# UNITED STATES PATENT AND TRADEMARK OFFICE

10/622,325

<b>Office Action Summary</b>	<b>Application No.</b> 10/622,325	<b>Applicant(s)</b> CALDERWOOD ET AL.	
	<b>Examiner</b> Allen C. Ho	<b>Art Unit</b> 2882

## DETAILED ACTION

*Fig. 1*

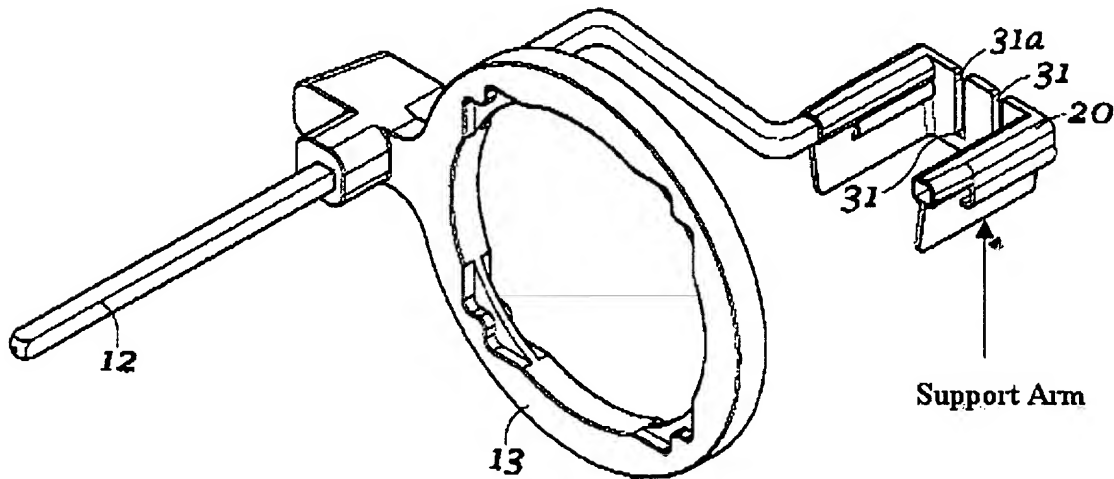
With regard to claim 19, Eppinger *et al.* disclosed a dental radiography anterior imaging bar comprising an aimer ring bar (12) supporting an anterior imaging platform; where the anterior imaging platform has two pressure slots (31, 40) and an angled base (20, 20a, 20b); and

where the aimer ring bar has an S-curve to support an aimer ring; and where the imaging platform further comprises two support arms extending from below the pressure slots to provide support to the anterior sensor holder (Fig. 1).
